# RENESAS TECHNICAL UPDATE

Product Category	MPU&MCU		Document No.	TN-H8*-A404A/E	Rev.	1.00
Title	Correction of errors in the H8SX/1651 Group Hardware Manual		Information Category	Technical Notification		
Applicable Product	H8SX/1651 Group	Lot No.	Reference Document	H8SX/1651 Group Hardware Manual (REJ09B0248-0200)		
		All lots

(1) Page 239, correction of initial values of bits 31 to 0 in DBSR

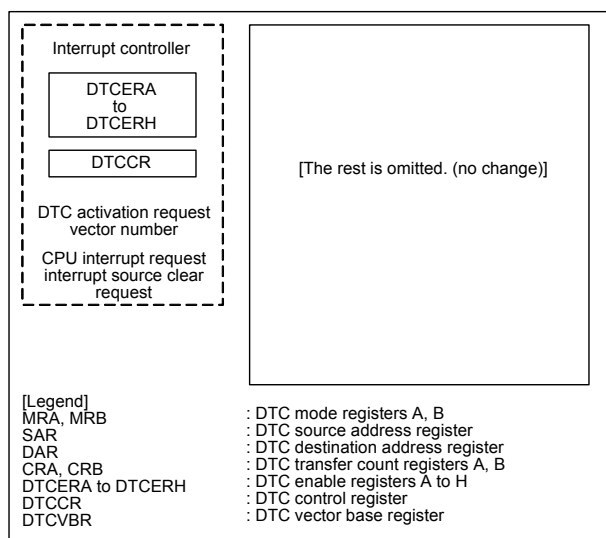
Bit	Bit Name	Initial Value	R/W	Description
31 to 16	BKSZH31 to BKSZH16	Undefined	R/W	– Description omitted (no changes) –
15 to 0	BKSZ15 to BKSZ0	Undefined	R/W	– Description omitted (no changes) –

Bit	Bit Name	Initial Value	R/W	Description
31 to 16	BKSZH31 to BKSZH16	0	R/W	– Description omitted (no changes) –
15 to 0	BKSZ15 to BKSZ0	0	R/W	– Description omitted (no changes) –
